Project	IEEE 802.16 Broadband Wireless Access Working Group < http://ieee802.org/16 >	
Title	Periodic Ranging protocol update	
Date Submitted	2006-09-26	
Source(s)	Giulio Cavalli Siemens SS11 Padana Superiore km158 20060 Cassina de Pecchi (Milano) Italy	Voice: +39 0224376380 Fax: +39 0224376726 mailto: giulio.cavalli@siemens.com
Re:	Call for contribution	
Abstract	Periodic ranging alignment	
Purpose	update	
Notice	This document has been prepared to assist IEEE 802.16. It is offered as a basis for discussion and is not binding on the contributing individual(s) or organization(s). The material in this document is subject to change in form and content after further study. The contributor(s) reserve(s) the right to add, amend or withdraw material contained herein.	
Release	The contributor grants a free, irrevocable license to the IEEE to incorporate material contained in this contribution, and any modifications thereof, in the creation of an IEEE Standards publication; to copyright in the IEEE's name any IEEE Standards publication even though it may include portions of this contribution; and at the IEEE's sole discretion to permit others to reproduce in whole or in part the resulting I

Figure 82 – Periodic Ranging receiver process -BS

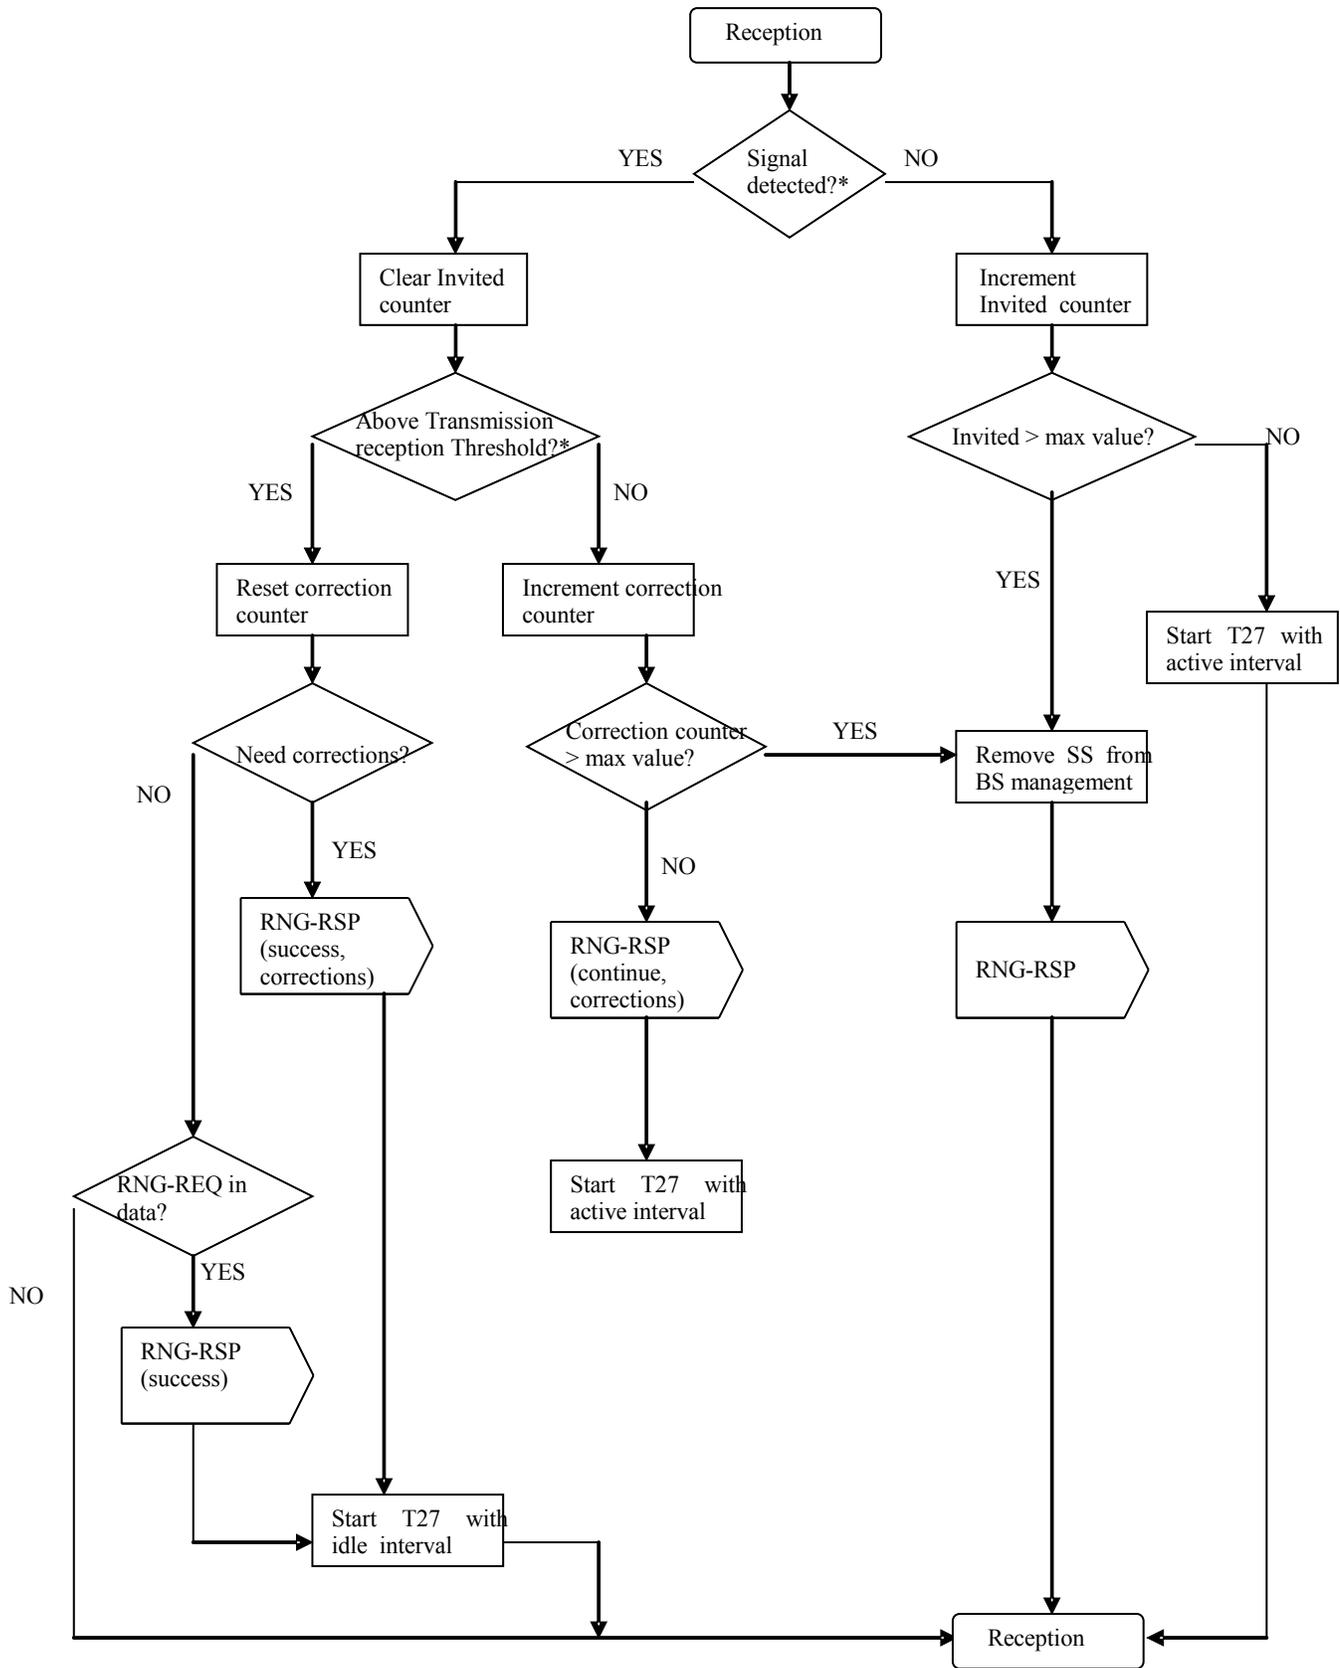
Replace figure 82 with the figure depicted below:

(*) it is implementation dependent
